ADDENDUM NO. 3

Project: American Legion Core Academic Renovation

**AMERICAN LEGION HIGH SCHOOL
CORE ACADEMIC AND CAMPUS RENOVATION
SACRAMENTO CITY UNIFIED SCHOOL DISTRICT
DSA App # 02-116158; DSA File # 34-H7**

ADDENDUM # 3 – REBID
July 25, 2018

JOB NUMBER: SHEET NUMBER:
 DATE: 28 SEPTEMBER 2017
 REVISION:
ADD-3R C2.1

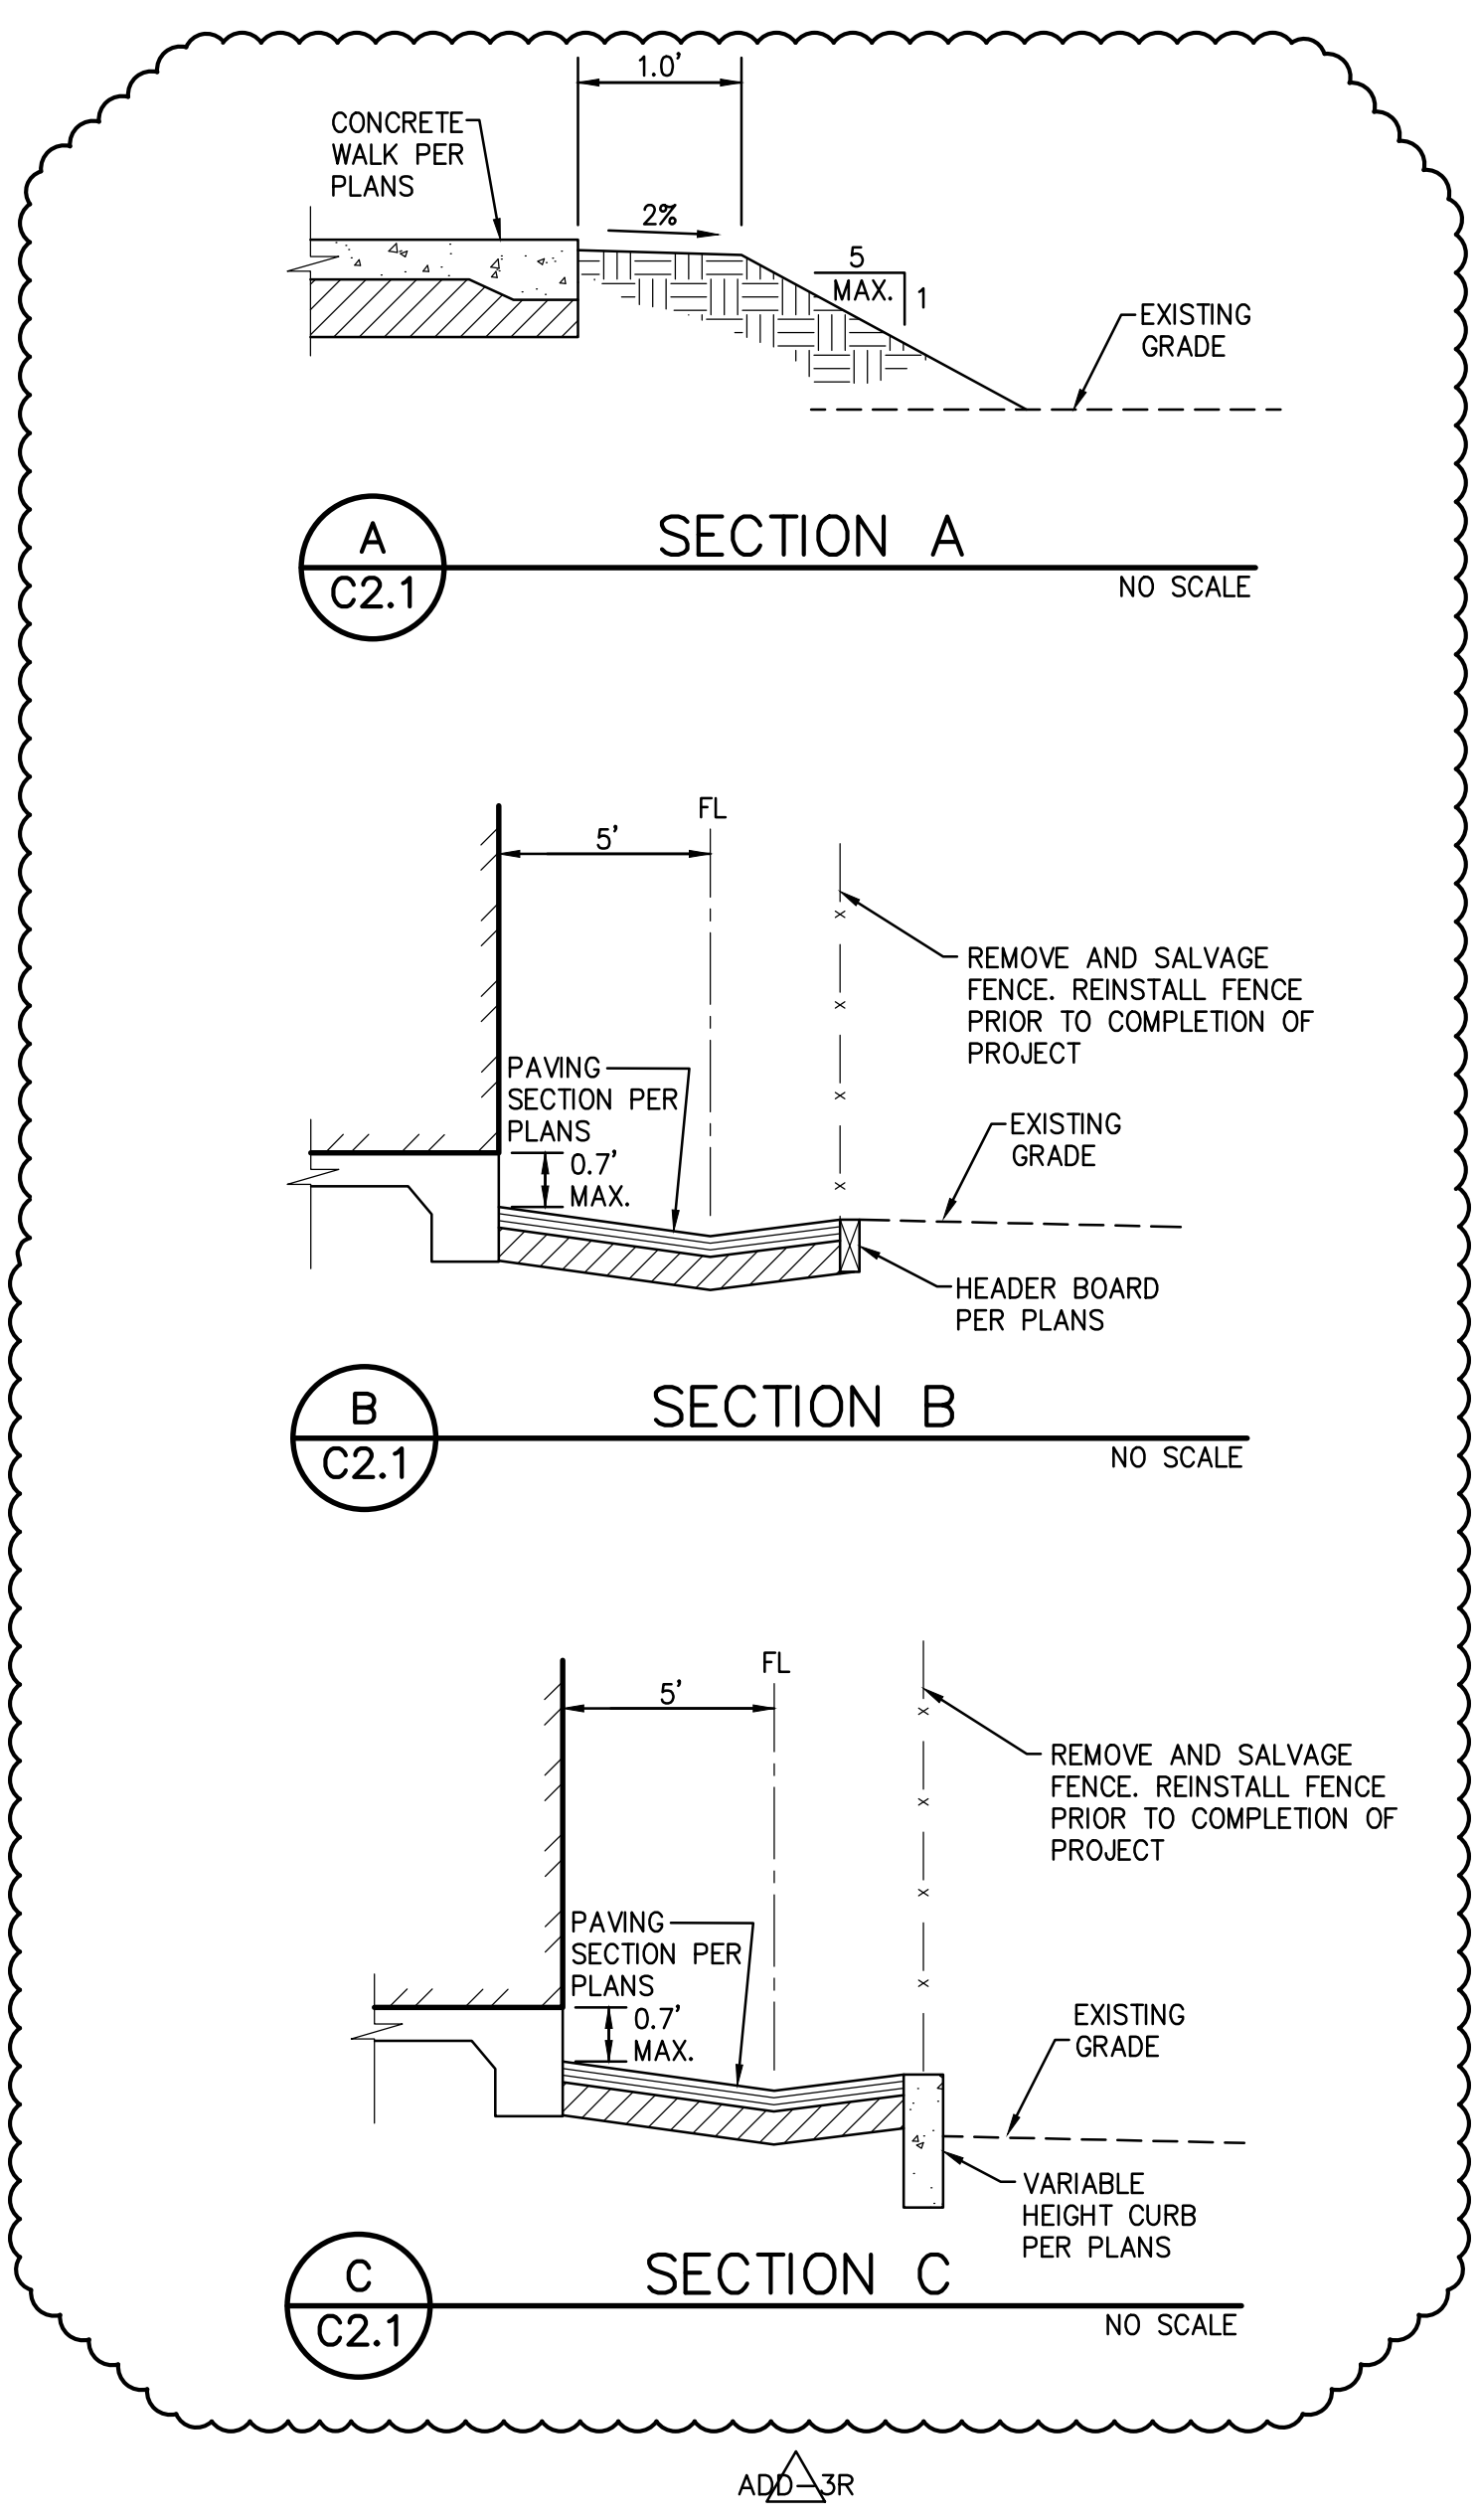
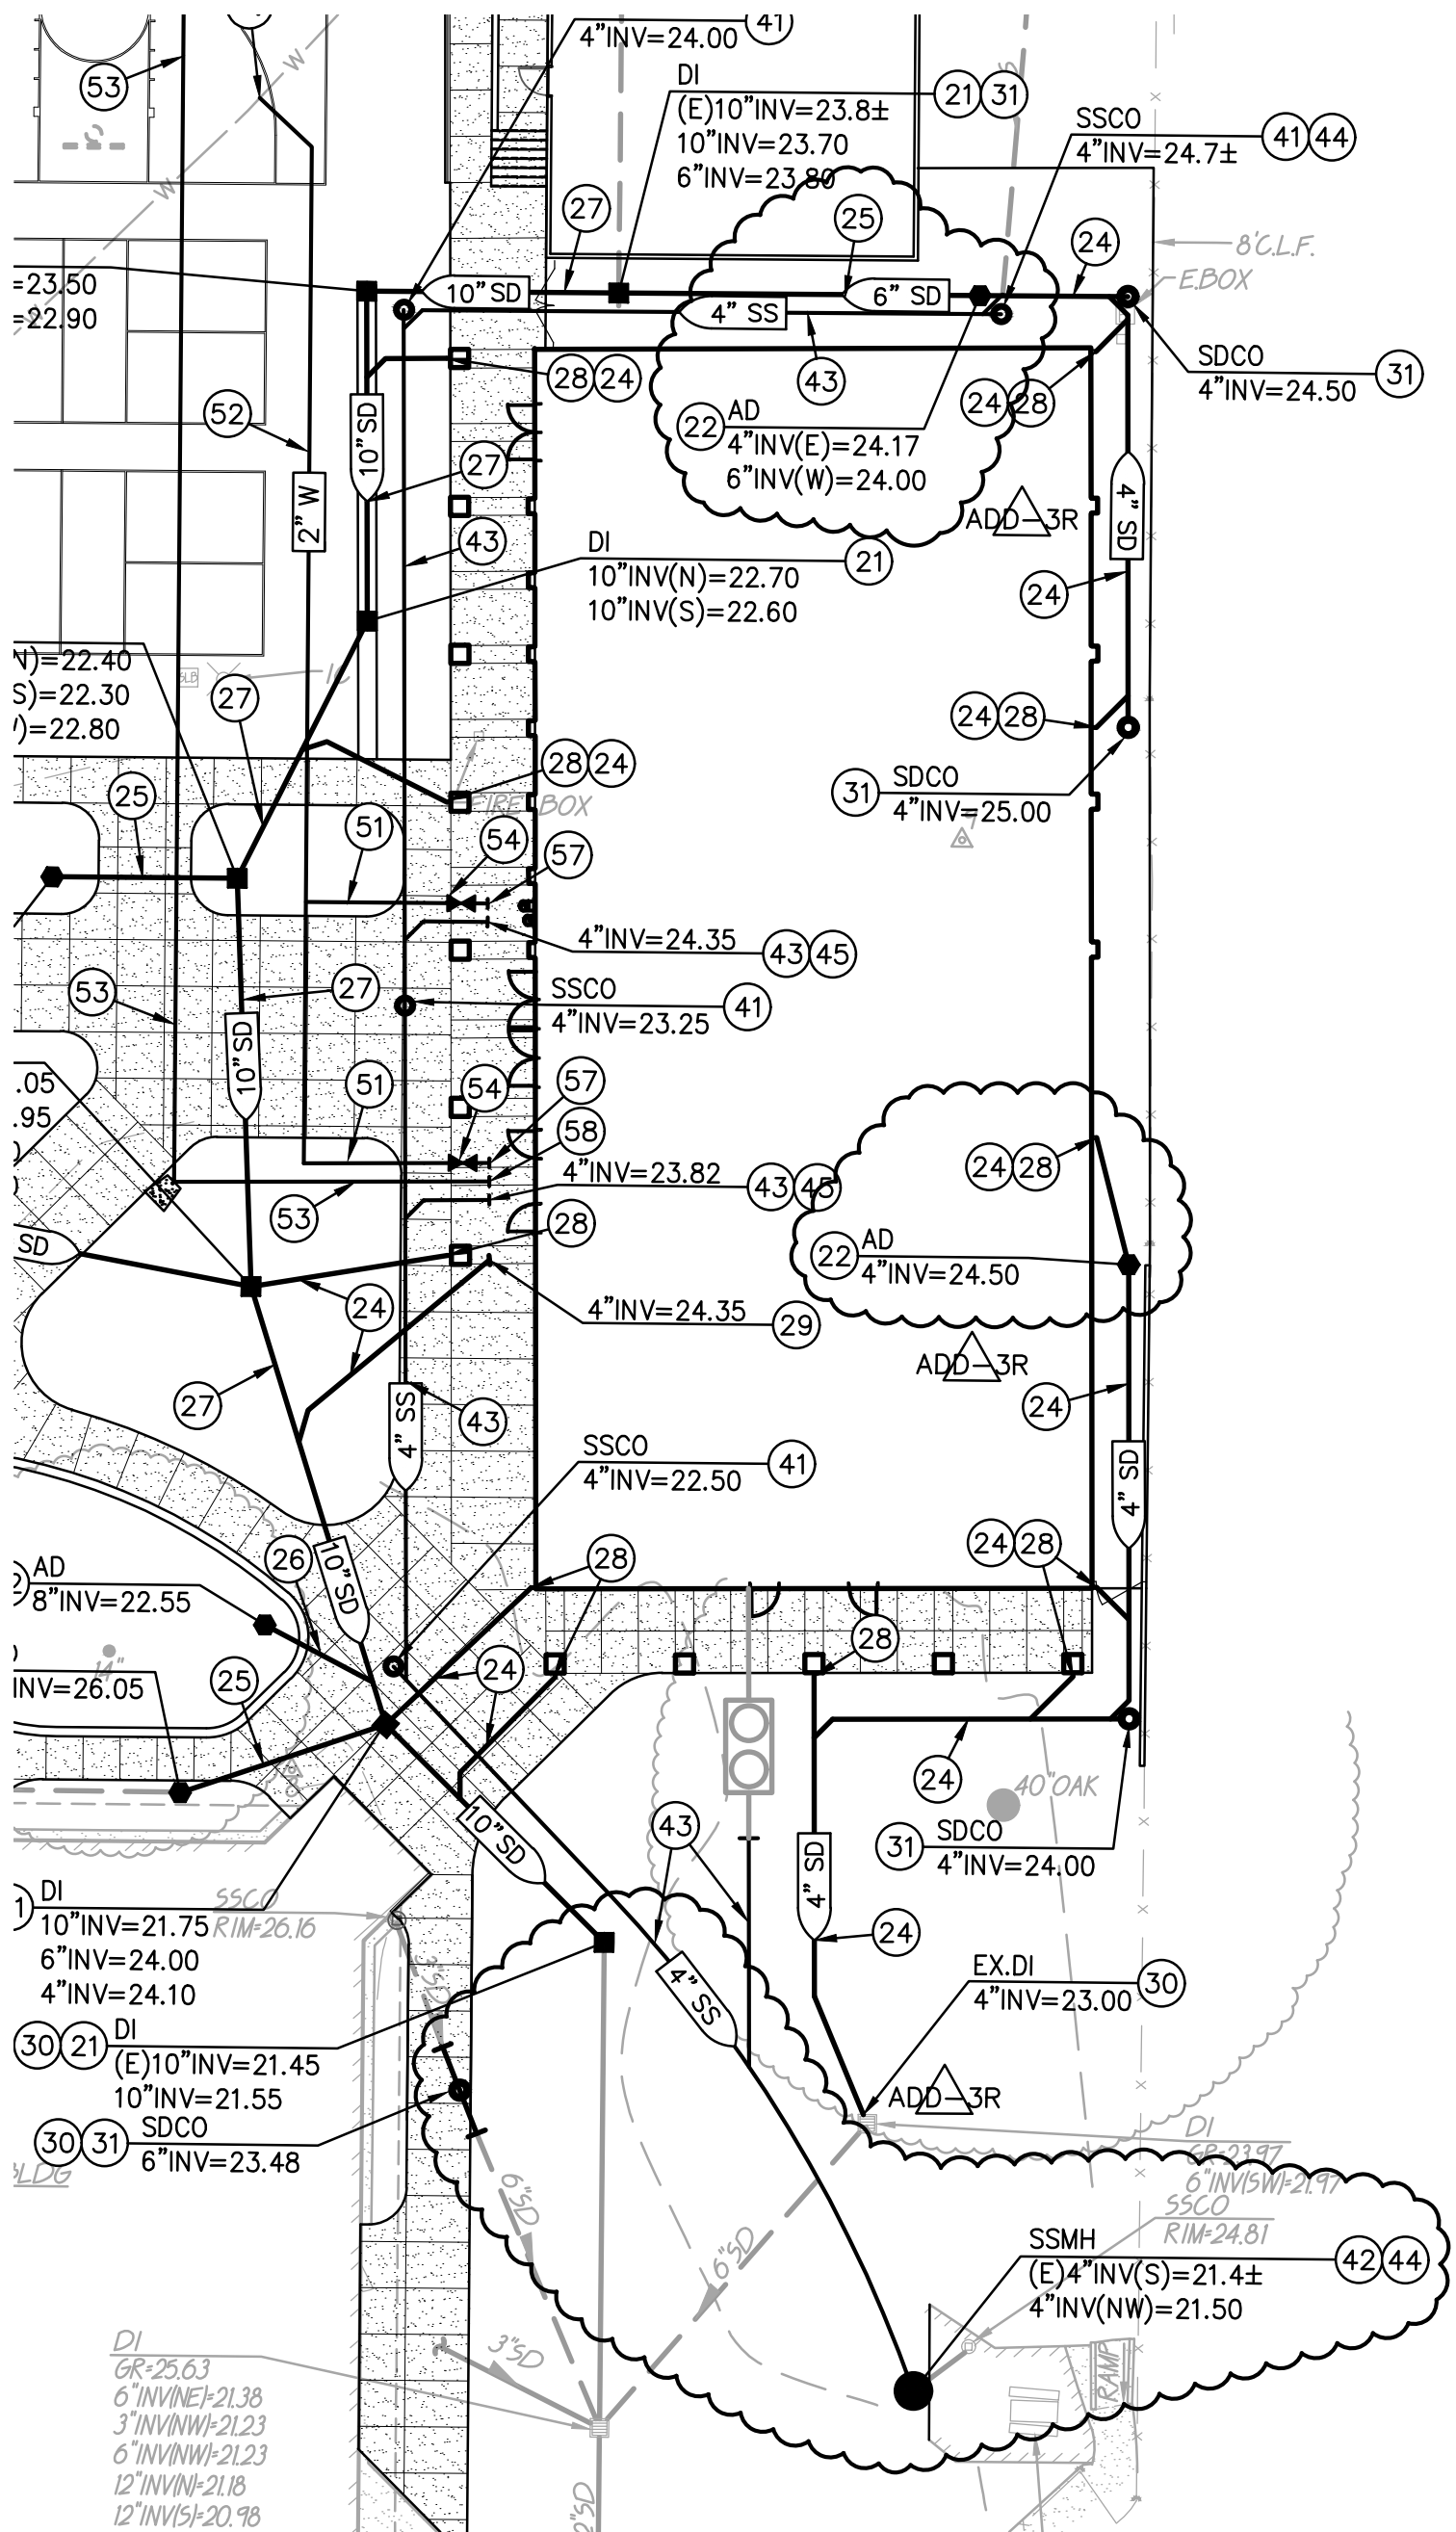
ITEM # 3R.10 Sheet ADD-1R C2.1 – Grading Plan: Replace with the attached Sheet **ADD-3R C2.1 – Grading Plan**. All changes have been clouded.

- GRADING NOTES**
- MATCH EXISTING GRADE/ELEVATION.
 - MATCH EXISTING FINISH FLOOR ELEVATION.
 - GRADE UNIFORMLY TO SWALE AND/OR INLET.
 - CONSTRUCT CONCRETE CURB PER (1) C6.1
 - TAPER FINAL 6" OF CURB FROM FULL HEIGHT WITH FINISH GRADE.
 - CONSTRUCT FLUSH CURB PER (2) C6.1
 - RE-INSTALL BENCHES.
 - CONSTRUCT CONCRETE VALLEY GUTTER PER (10) C6.1
 - CONSTRUCT GUARD RAIL PER (1) C6.2
 - CONSTRUCT STAIRS PER (2) C6.2
 - OVER EXCAVATE A MINIMUM OF 2 FEET BELOW EXISTING OR FINISHED SITE GRADES, WHICHEVER IS LOWER, PER SPECIFICATIONS AND GEOTECHNICAL REPORT.
 - CONSTRUCT CONCRETE SEAT WALL PER (6) C6.2
 - CONSTRUCT VARIABLE HEIGHT CURB PER (13) C6.1
 - VEHICLE PULL UP SPACE AND LOADING AREA SHALL NOT EXCEED 2% IN ANY DIRECTION.
 - CONSTRUCT HEADER BOARD PER (14) C6.1
 - 2% MAX TO EXTENT SHOWN AT GATE.
 - NEW FENCE PER ARCHITECTURAL PLANS.

C3.1A

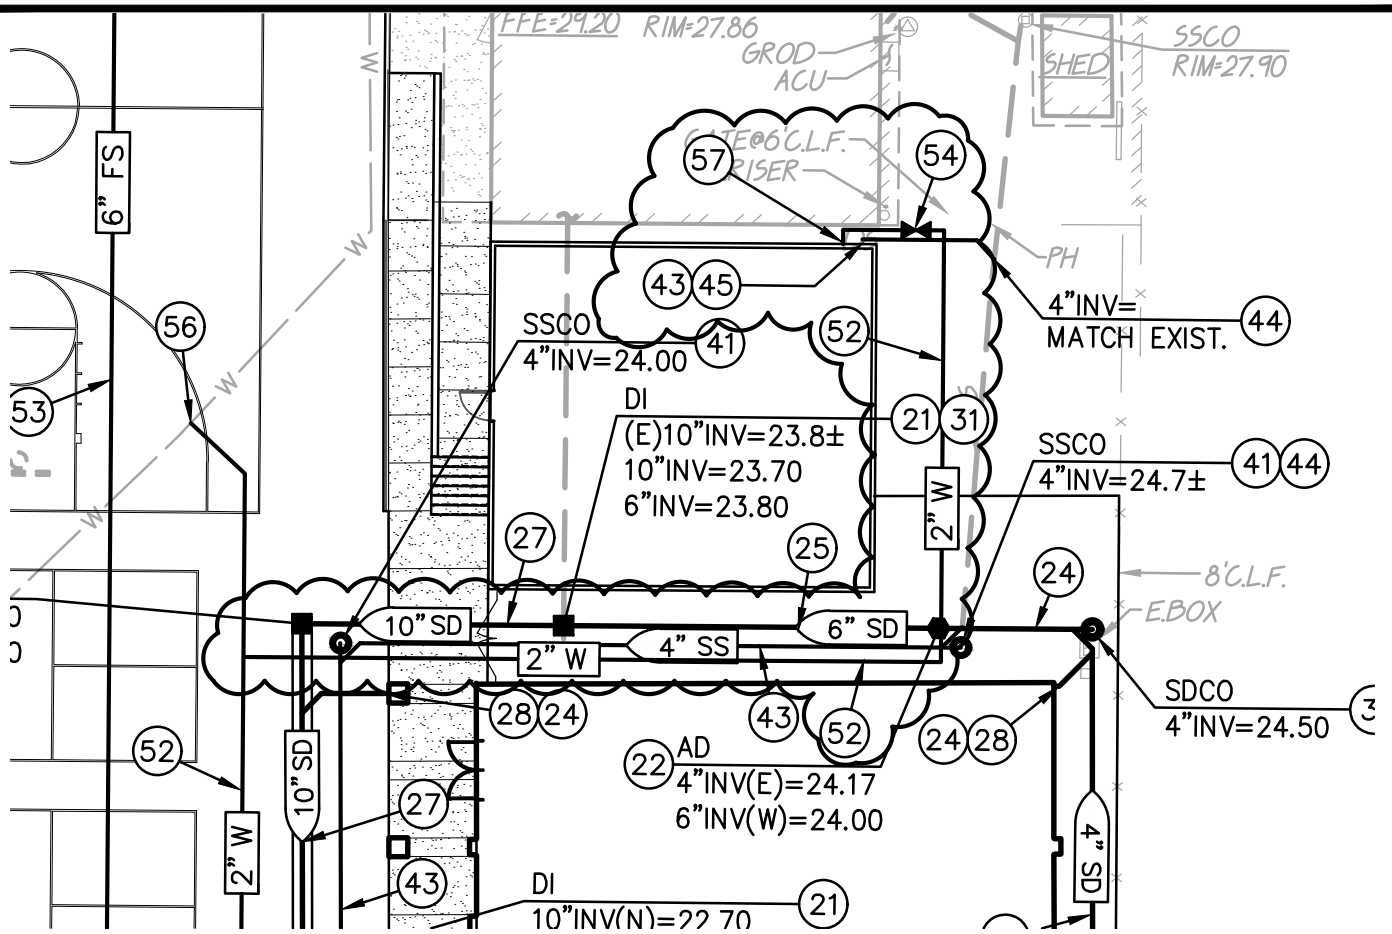
ITEM # 3R.11 Sheet ADD-2R C3.1 – Utility Plan: Update this Sheet as shown on the attached **ADD-3R C3.1A** and **ADD-3R C3.1B**. All changes have been clouded.
